**40 CFR 190**  
**ENVIRONMENTAL RADIATION PROTECTION**  
**REQUIREMENTS FOR NORMAL OPERATIONS**  
**OF ACTIVITIES IN THE**  
**URANIUM FUEL CYCLE**

**FINAL ENVIRONMENTAL STATEMENT**

**VOLUME II**

## IX. RESPONSE TO COMMENTS

Figure Caption

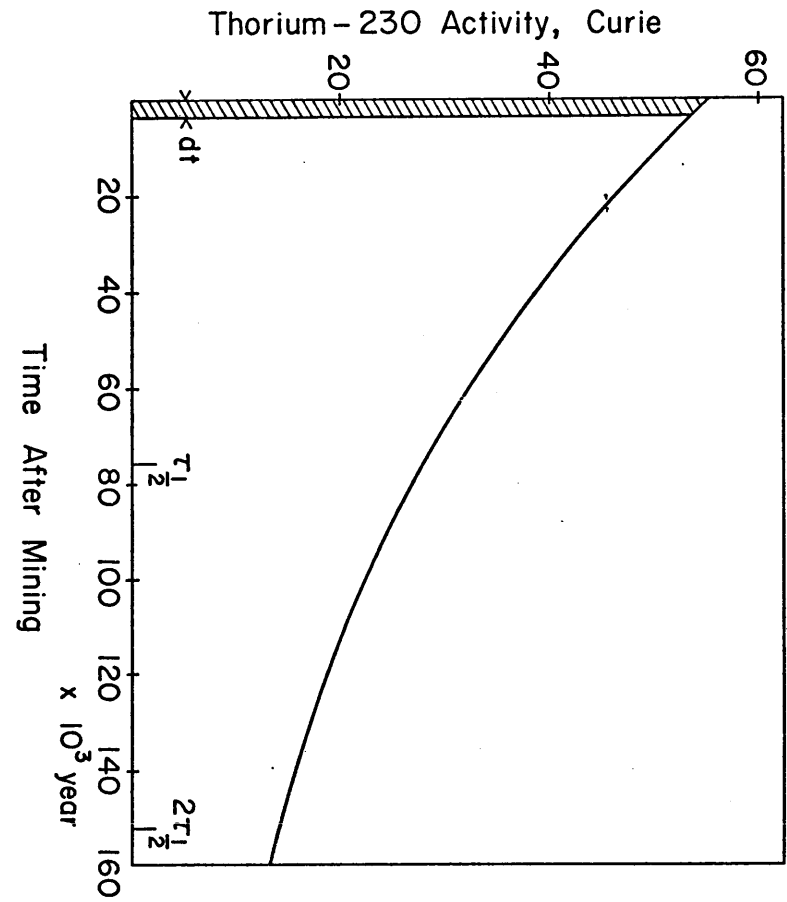
A: The activity of the thorium-230 set free by burning coal follows the exponential time dependence shown in Fig. 1, except that, per GW(e)y, the scale on the vertical axis will be 50 times smaller. The uranium in the ash, however, will cause the thorium activity to remain constant for the order of a billion years, since the decaying thorium-230 is constantly replenished by the uranium-238. Of course, the same problem will be encountered with the uranium-238 presently stored at the nuclear fuel enrichment plant, unless ways are found of either burning it in a breeder, or else disposing of it safely.

Table 1  
EPA Required Cases for PWR (see Figure 12)

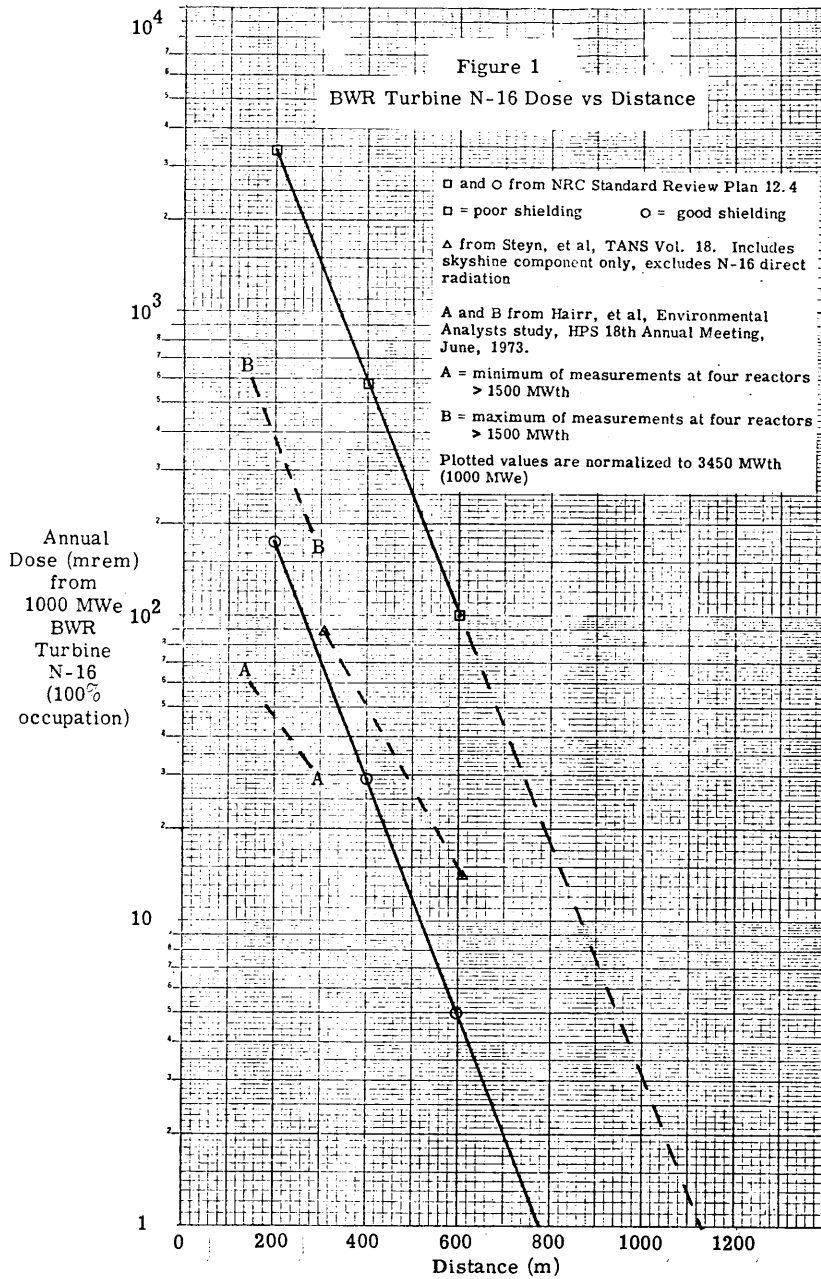
Figure 12 of the DES lists 22 items which EPA claims are required to meet the proposed standard for FWR. These are listed in attached

Our preliminary analysis of the PWR cases listed on Figure 12 of the DES (an analysis which will be detailed and extended in our Hearing testimony) indicates that, for a single PWR at a site, the gaseous re-

Figure 12 of the DES also lists 23 items which EPA claims are required to meet the proposed standard for BWR. These are listed in attached Table 2. Of the 23 items only twelve are cost-effective even by EPA's own definition. Of these twelve, all but the two associated with re-processing are already industry practice. Eleven of the required controls are not cost-effective even by EPA's own values. Of these eleven non-cost-effective controls, industry is already using 6 1/2, despite their lack of cost-effectiveness.
